PLAN AND ZONING COMMISSION MEETING

CITY OF DAVENPORT, IOWA

Subject:
Case F26-08: Request of 53rd Luxury LLC for a Final Plat of Speer Commercial Park 3rd Addition. The 5-lot subdivision is located at 1777 East 53rd Street, on 28.3 acres. [Ward 8]

# SPEER COMMERCIAL PARK 3RD ADDITION

DRAWING TITLE: FINAL PLAT OF SUBDIVISION

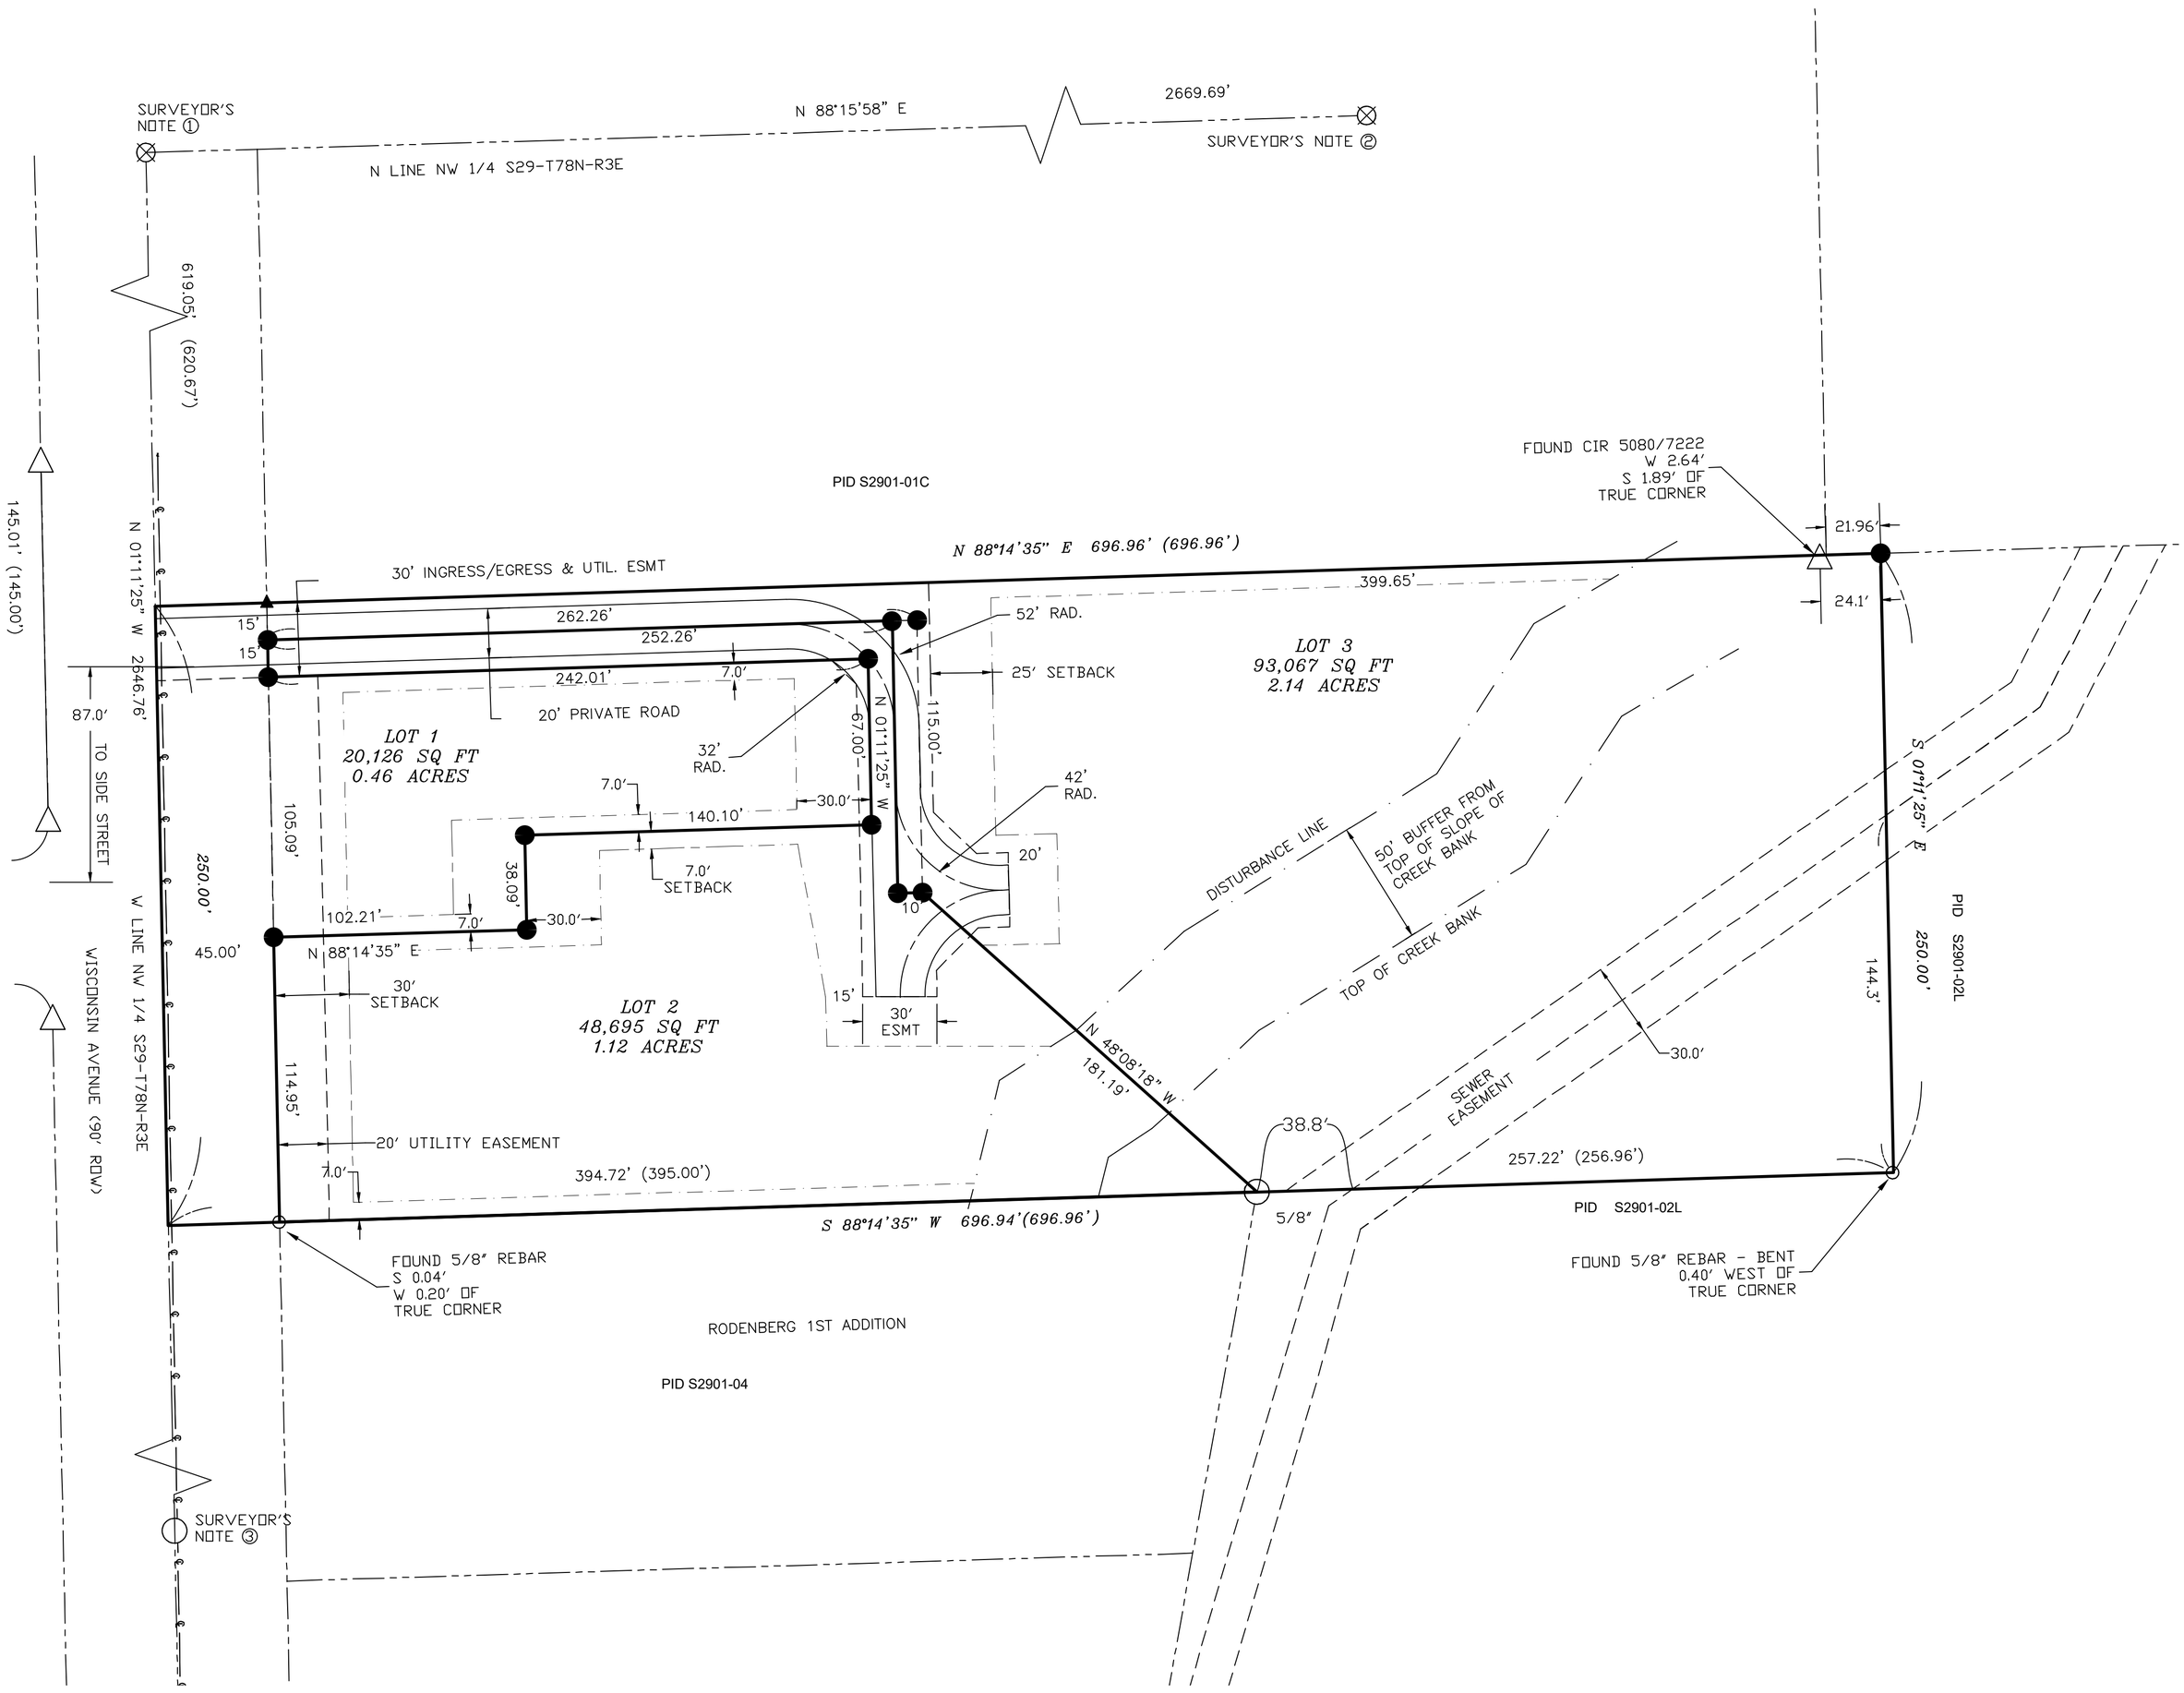
1. That the surveyor signs the plat.
2. That the utility providers sign the plat when their easement needs have been met.
3. The final plat shall be revised to dedicate a strip of land along the western property boundary as public right-of-way, in a width sufficient to align with the existing right-of-way boundary at 1551 Wisconsin Avenue, as determined by the City Engineer.
4. The final plat shall be revised to depict and dedicate a drainage easement along Crystal Creek that includes a minimum fifty-foot (50') buffer on both sides of the stream, in accordance with Section 13.34.070. of the Davenport Municipal Code.
5. Add a note stating "No stormwater detention or water quality treatment will be required with this subdivision, but may be required upon further development."

1. Zoning: The proposed Final Plat complies with the dimensional requirements of the R-1 Single-Family Residential District. The lots exceed minimum lot area requirements and provide adequate frontage and building envelopes for future residential development.
